APICAL INDUSTRIES, INC.
dba DART AEROSPACE

ENGINEERING CHANGE NOTICE NO.

07036

DWG NO. 647.3000

SHEET 1, LEFT HAND VIEW WAS:

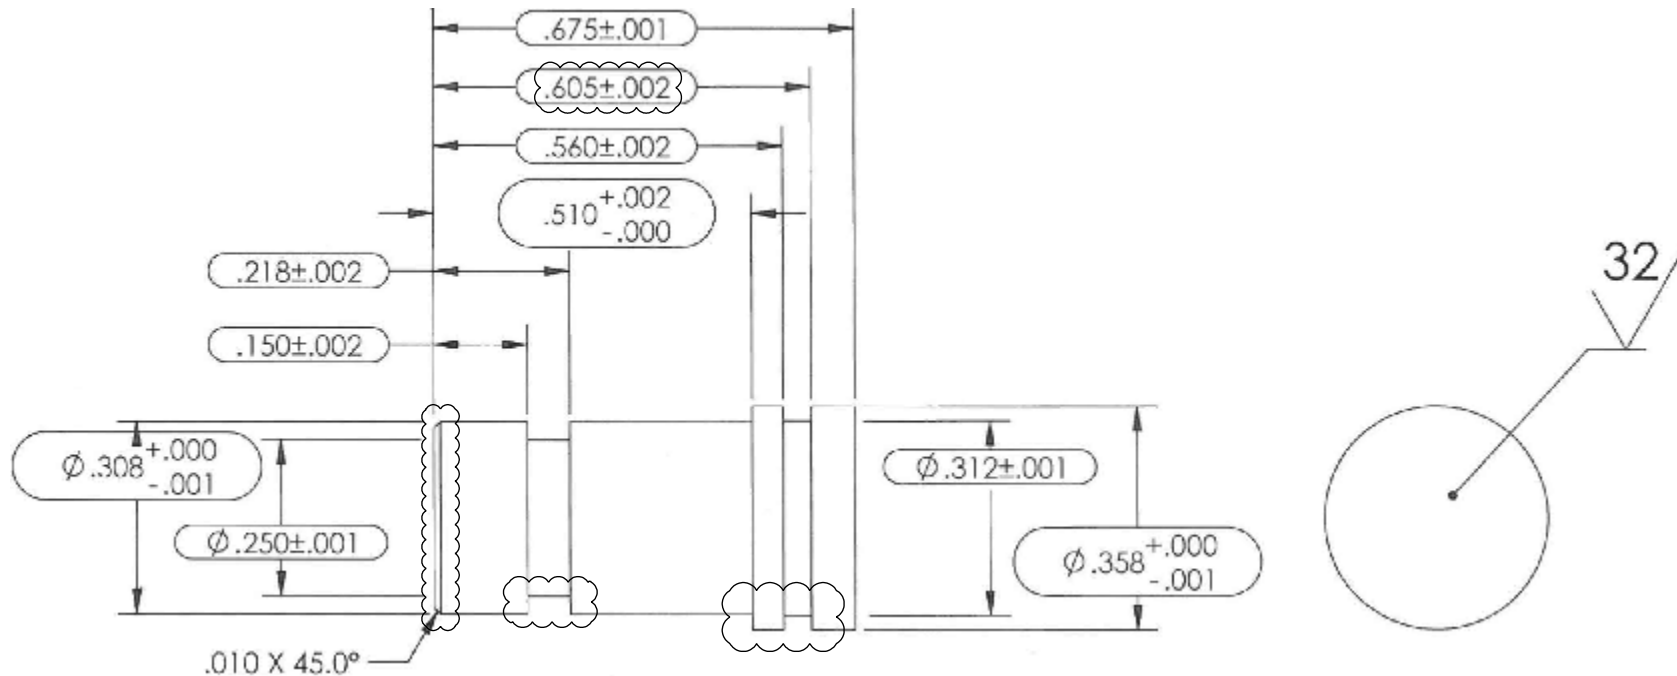
REASON: REVISED TEMPLATE AND VIEWS FOR CLARITY. REVISED NOTES. REVISED O-RING GROOVE DIMENSIONS. ADDED SURFACE ROUGHNESS VALUES AND RADII (FOR MACHINING) AS REQUIRED.

SHEET 1, NOTES WAS:

1. DEBURR AND BREAK ALL SHARP EDGES
2. MATERIAL: STAINLESS STEEL 17-4 H1150
3. IDENTIFY IAW MPP-120
